TIRUMAL NAICKS' PALACE - MADURA.

20TH AUGUST 1888, No. 2563 W., PUBLIC WORKS.

Tirumal Naick's Palace, Madura

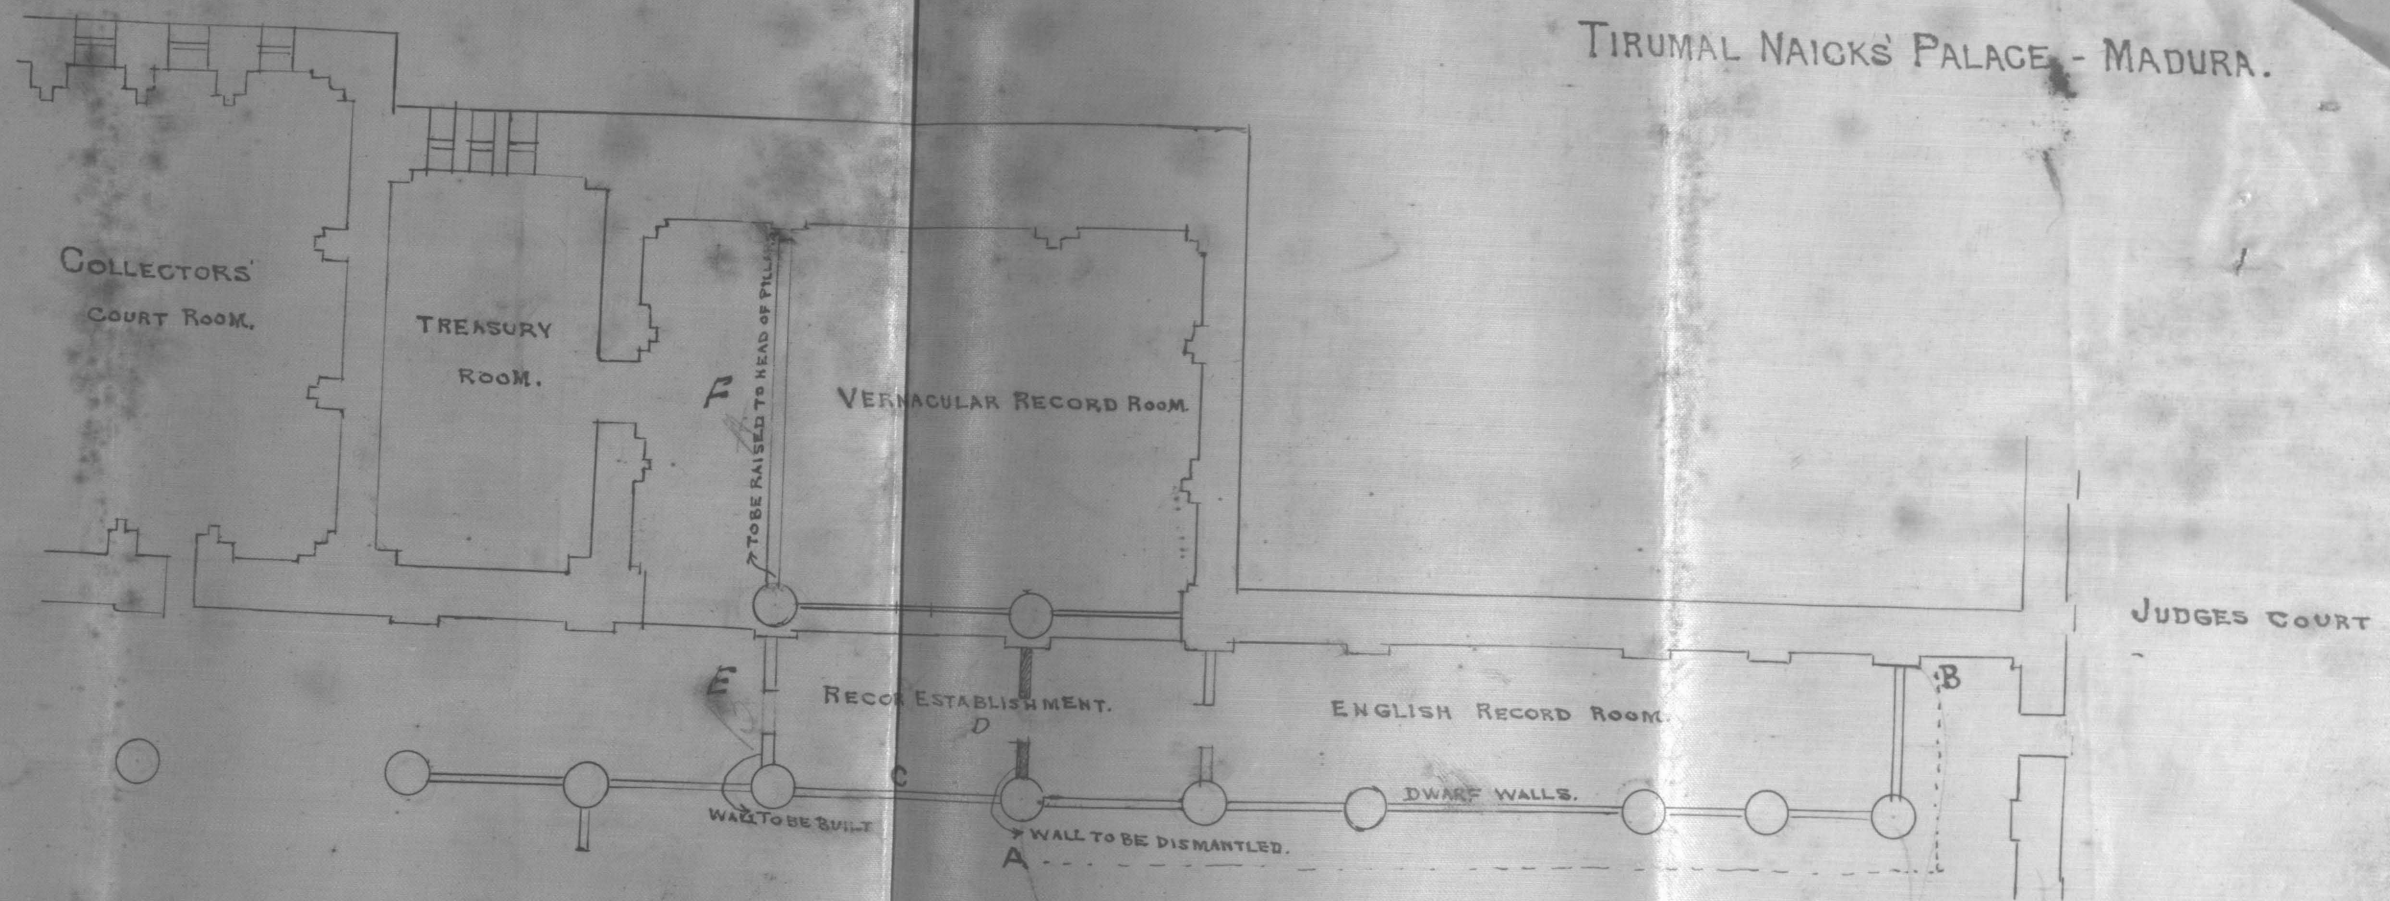
(1) Wire netting behind the cast iron railings above the dwarf wall marked A & B in the plan should be provided.

(2) Wire netting from the bottom of cast iron railing to the height of 16 feet (similar to the other bays of the record-room) should be provided in the bay marked C, in the plan.

(3) The wall marked D in the record room & the beliskment to be dismantled and the door removed.

(4) A new wall at E will be constructed and the old door removed at D will now be fixed at E.

(5) The wall at F will be raised to the head of Pillar and the present railing will be fixed over the wall.
